**From:** [REDACTED]@rwe.com  
**Sent:** 20 June 2024 10:32  
**To:** Byers Gill Solar  
**Cc:** [REDACTED]@arup.com; [REDACTED]@arup.com; [REDACTED]@arup.com; [REDACTED]@arup.com; [REDACTED]@burgess-salmon.com; [REDACTED]@burgess-salmon.com  
**Subject:** RE: Byers Gill Solar - new or revised information  
**Categories:** With ExA

### **Description of the updated information**

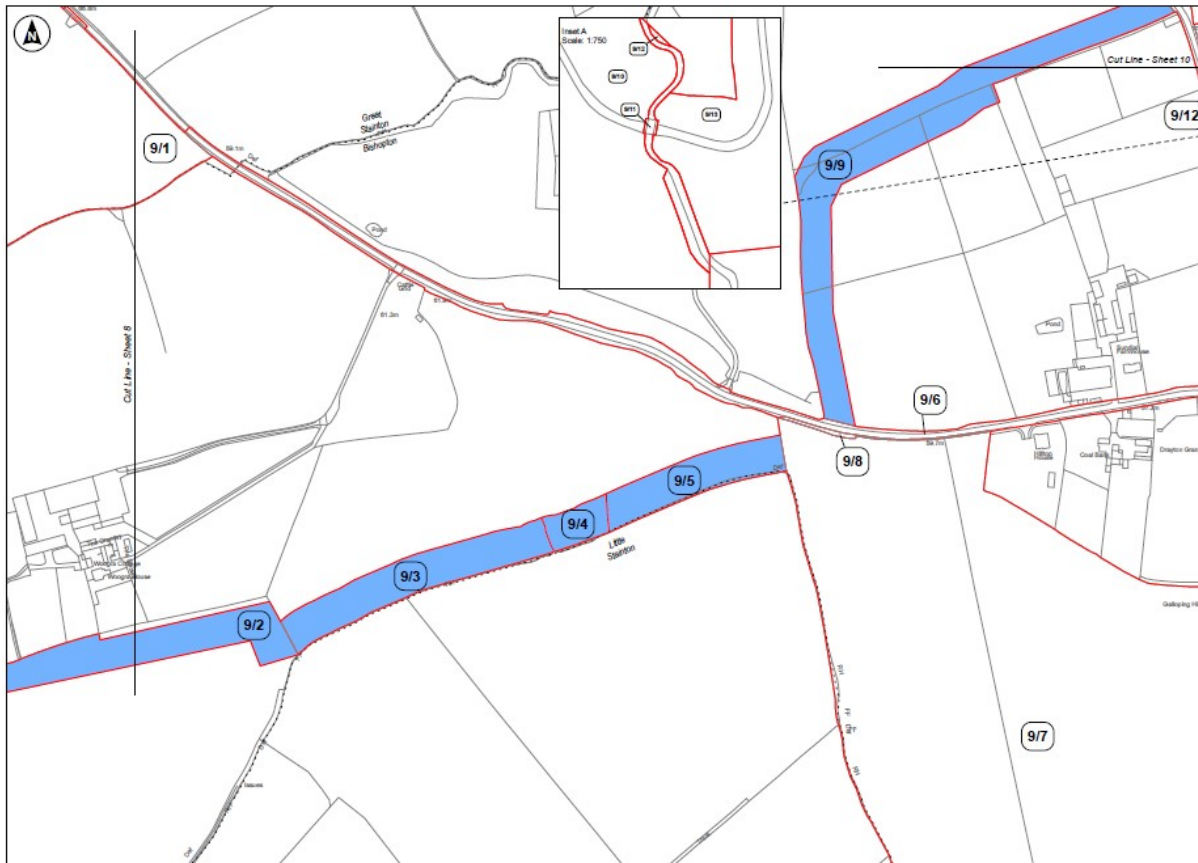
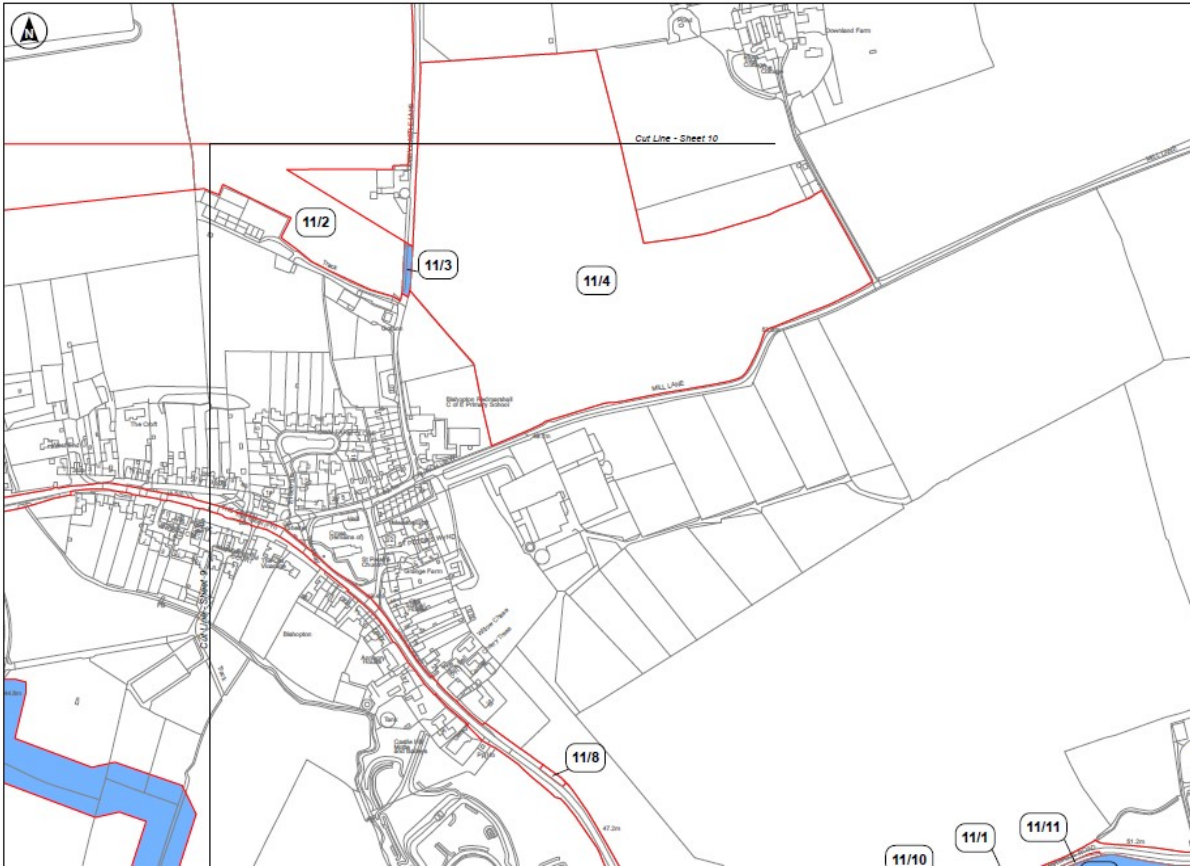
Accordingly, the completion of the Easement Option concludes the negotiations between the Applicant and [REDACTED] (the landowner) in respect of plots 9/16, 11/5, 11/6 and 11/7 referred to in Appendix B of the Statement of Reasons [Document Reference: APP-014]. These plots comprise the section of off-road option to the south of Bishopton, as shown on extracts from sheet 9 and 11 of the Land Plans [Document Reference: APP-010] below. This also shows the existing Red Line Boundary which contains the on-road cable option in Bishopton.

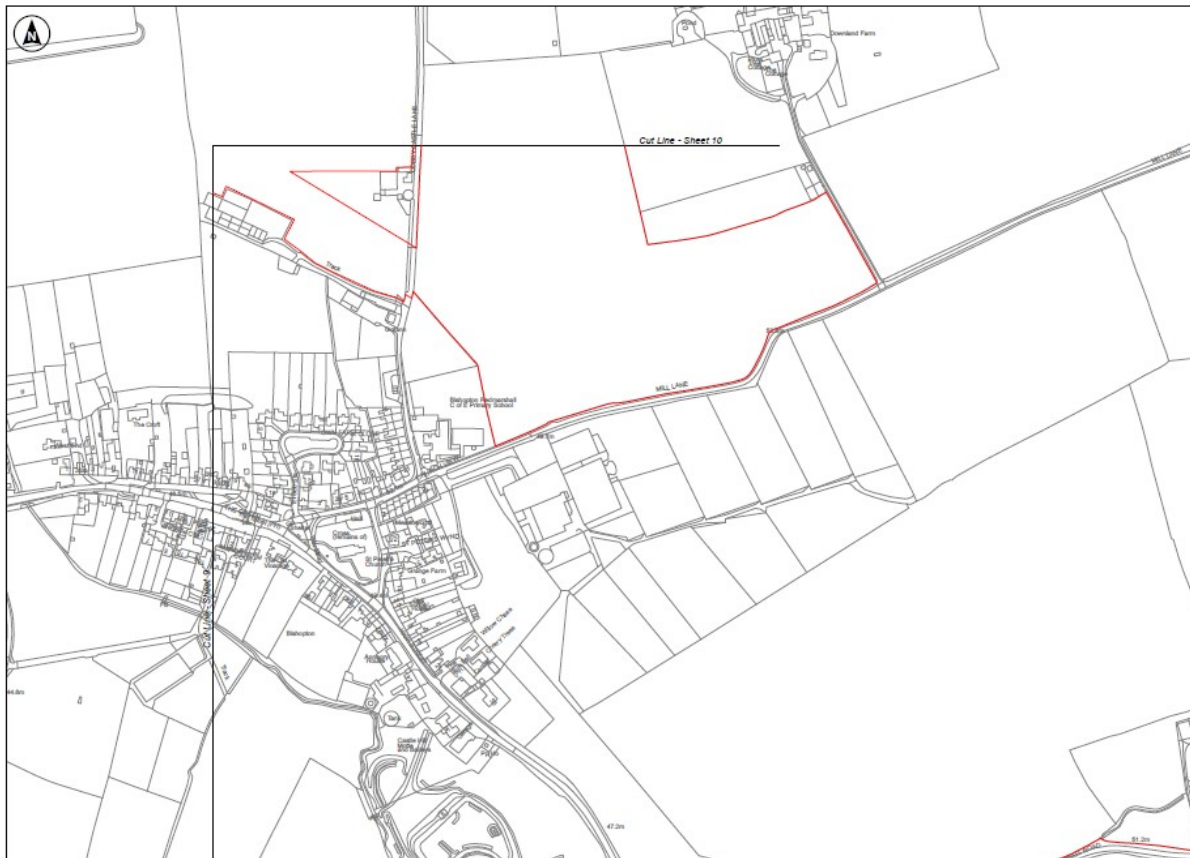
The update to the application would involve removing the on-road option for 132kV cabling which currently follows the section of adopted highway through Bishopton known as The Green and High Street. The proposed removal is shown on an indicative Red Line Boundary overview plan extract below. This land comprises part of plots 9/6 and 11/11 and the whole of plot 11/8 and is no longer necessary to guarantee delivery of the Proposed Development now that the Easement Option is secured.
